SWMU 48/49 RFI Report Correspondence

Re: Radford Army Ammunition Plant, Radford, Virginia
Solid Waste Management Units 48 and 49
RCRA Facility Investigation Report

Radford Army Ammunition Plant
SWMUs 48 and 49
RCRA Facility Investigation Report
Draft Document, January 2014

Responses to EPA/VDEQ comments (Dated November 5, 2012) on the
*Draft SWMU 48/49 RCRA Facility Investigation (RFI)/Corrective
Measures Study (CMS) Report June 2012*

FIGURE X-X

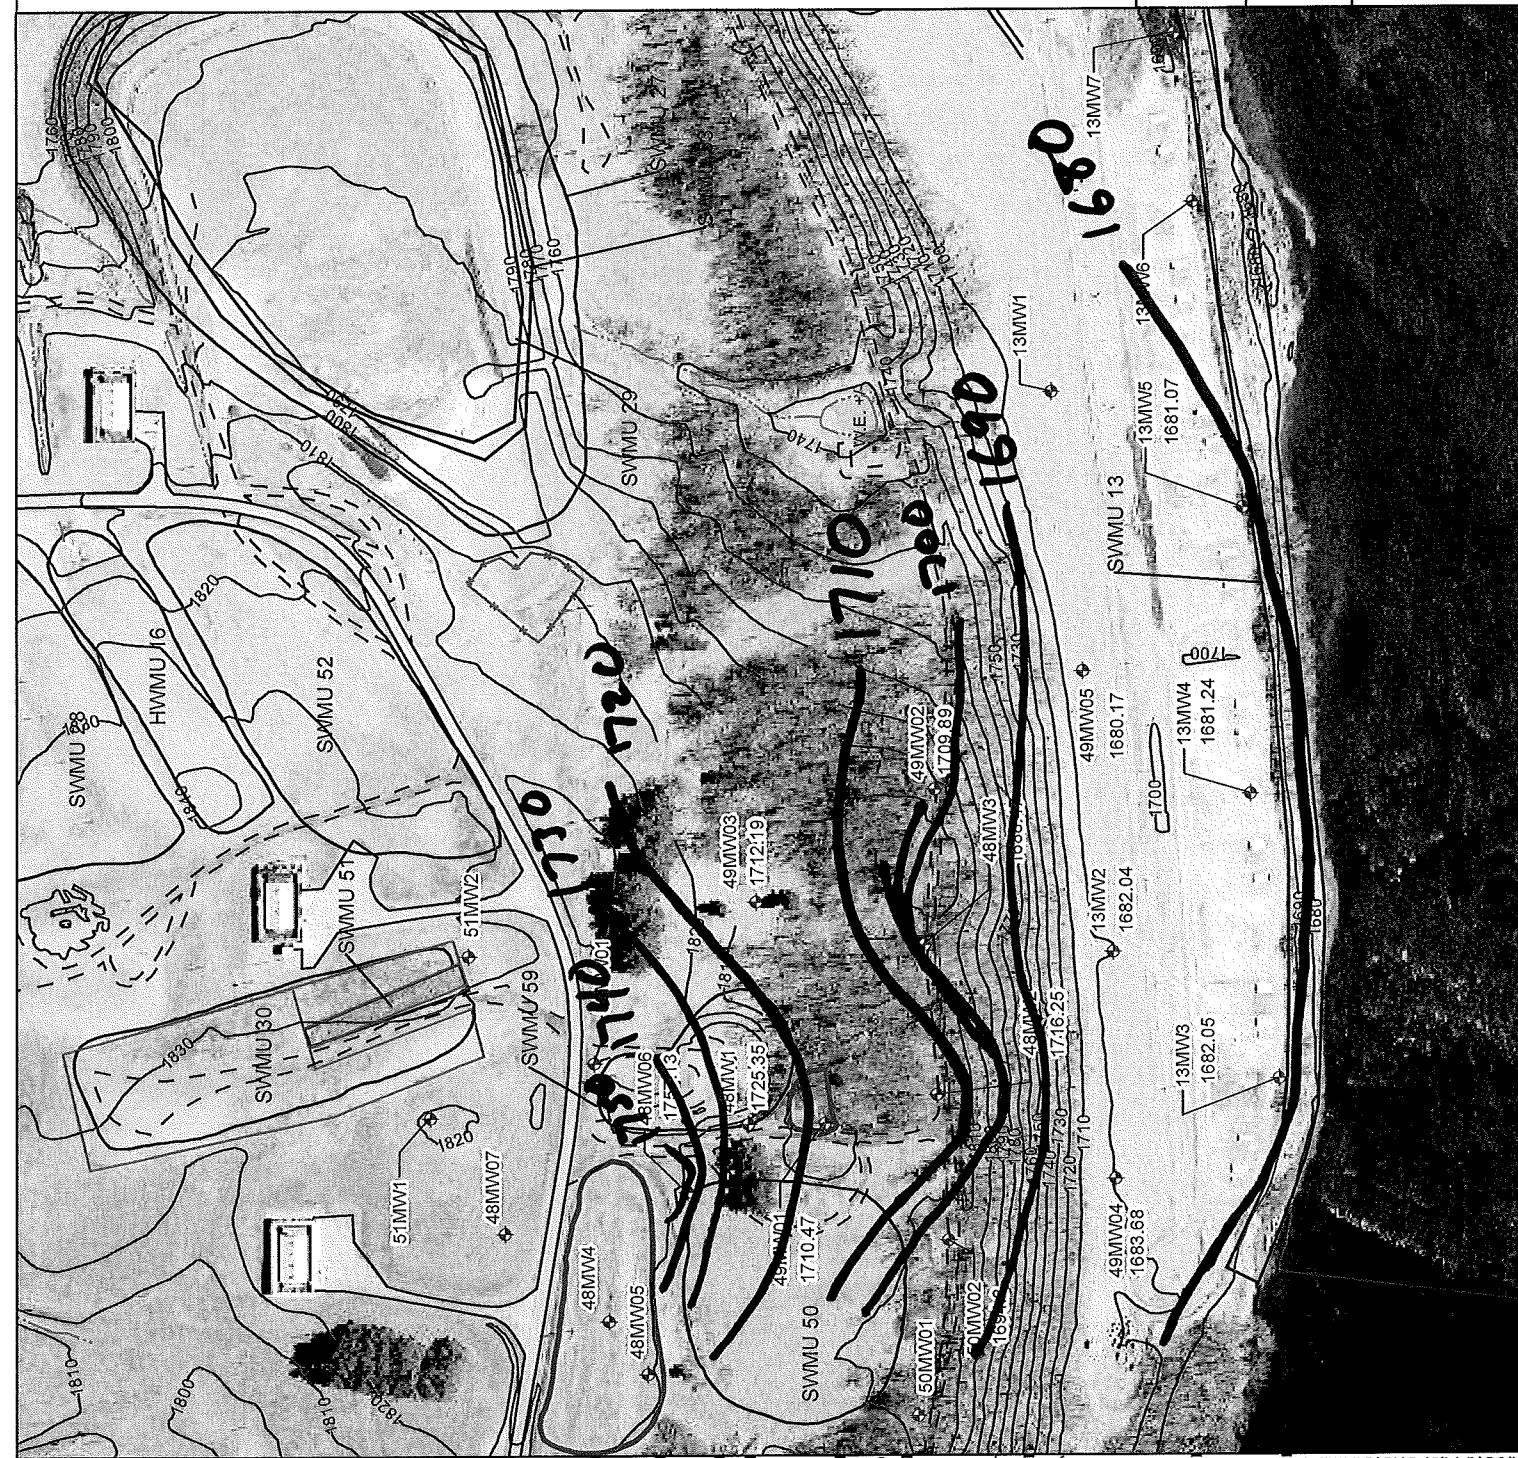
Here are some quick and dirty contours that include the new wells. I've included the contour map from the RFI as well, for comparison to how they fall in line with previous GW contours.

FIGURE 2-7

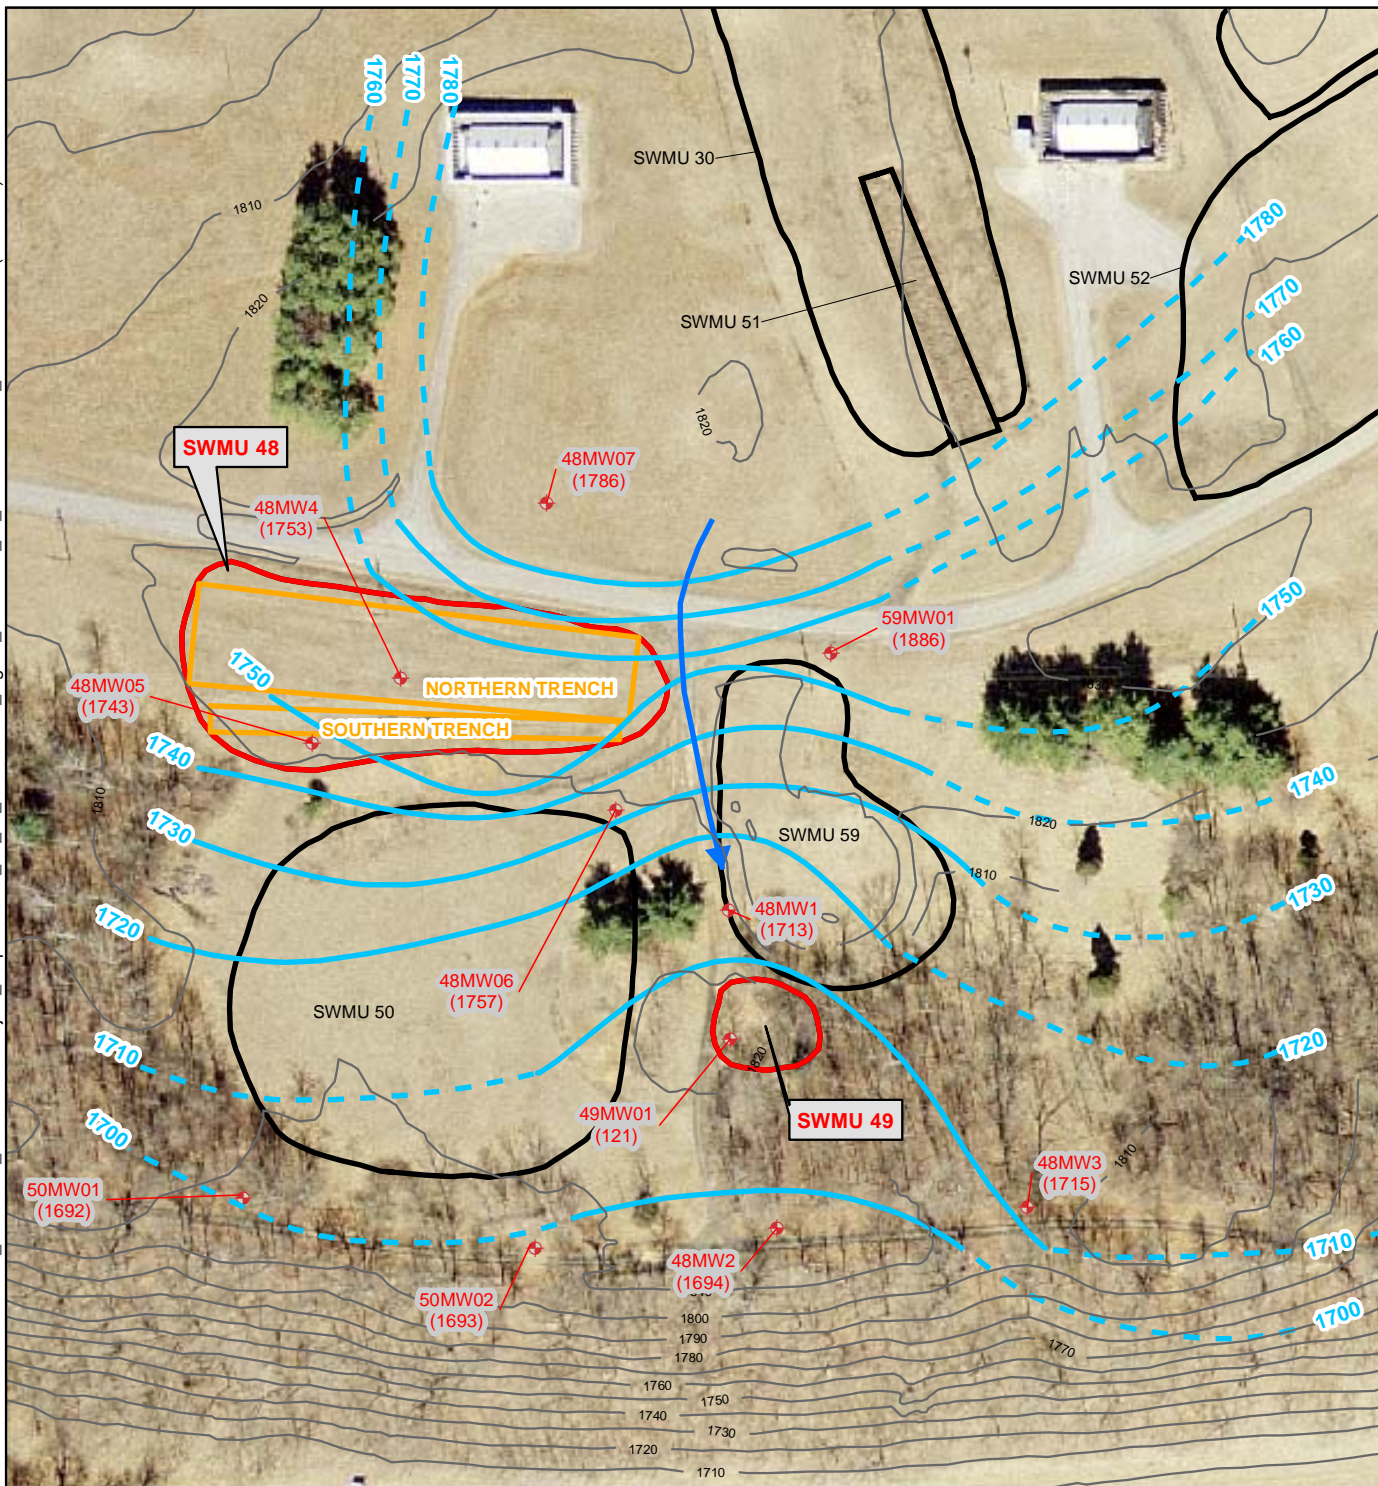
18. **Section 2.5, Site Hydrogeology, Page 2-6:** This section notes that well 49MW01 does not show a water level on Figure 2-7 because the well “was practically dry at the time of measurement (August 2007).” However, it appears that a groundwater sample was

64. **Section 9.2, Alternative Two: MNA and LTM, Page 9-4:** The wells proposed for LTM are identified under the subheading, Implementation/Rampdown Strategy. The descriptions of some of the wells do not appear accurate. For example, at SWMU 48, well 48MW06 is described as an upgradient well. However, Figure 2-7, Potentiometric Surface Map, shows 48MW06 downgradient of SWMU 48. Furthermore, 48MW07 is described as a downgradient well, but Figure 2-7 shows this well is upgradient of SWMU

Further, Section 4.3.2, Groundwater, notes that the 2007 data indicated that the highest VOC concentrations of TCE and carbon tetrachloride were detected in well 48MW2. Figure 2-7, SWMU 48 and SWMU 49 Potentiometric Surface Map, shows that well 48MW2 is the most downgradient well at the sites. The extent of contamination beyond well 48MW2 is currently unmonitored. Therefore, it is unclear how the current monitoring well network would include an appropriate number of groundwater monitoring wells to evaluate the effectiveness of the proposed MNA remedial alternative. Please revise the RFI/CMS to propose a network of both *new* and existing groundwater monitoring wells that will be monitored to evaluate the effectiveness of MNA, and as noted previously, to satisfy the RCRA requirements for long-term groundwater monitoring of a regulated unit. In addition, please provide a discussion regarding how the existing monitoring well data are sufficient to establish baseline groundwater conditions and how the existing/to-be proposed monitoring network will be appropriate for assessing remedial effectiveness.

RESPONSE: Additional wording was added to this section 2.5 to explain that the well had just enough water in it to collect a sample with a bailer. Water level was at depth in the well (121 ft bgs). This number was added to Figure 2-7. The well was installed at the depth of first encountered water to evaluate vertical migration from the site to the water table. The potential presence of TPH at this location guided the installation of the well so that part of the screen was above the water table to capture any potential free phase product. Despite the turbidity of the sample, the well is installed appropriately given the site conditions and is an acceptable monitoring point.

FIGURE 1
SWMU 48/49
PROPOSED MONITORING WELLS
Radford Army Ammunition Plant,
Radford, VA

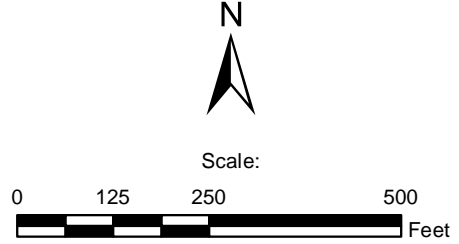
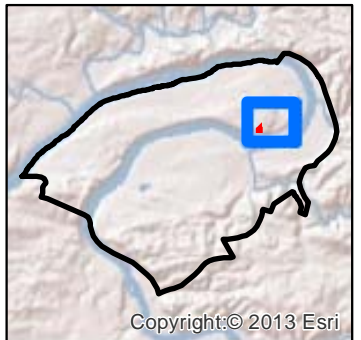
-Install 4 new wells at locations shown on attached figure (rather than 2 as proposed in the RTCs).

-Collect one round of samples (instead of 2 rounds) from the newly installed wells and existing wells (circled on the attached figure) Note the wells circled on the figure are a smaller subset than what is in the RTCs:

Proposed well locations to better delineate the extent and source of contamination are presented on **Figure 1**. **Figure 1** also shows the wells that are proposed for sampling as part of the baseline MNA sampling described above. The wells are also listed in **Table 1**, along with the rationale for including each well. Detailed descriptions of the parameters and rationale for inclusion are presented in **Table 2**.

RESPONSE: Two additional wells will be installed further east of existing monitoring well 48MW-03 (see **Figure 1**). Please note that the intent of this report is to characterize contamination originating from SWMUs 48/49. An interim measures action has been performed to remove soil and ash from the southern trench at SWMU 48 as the result of previous comments from EPA/VDEQ.
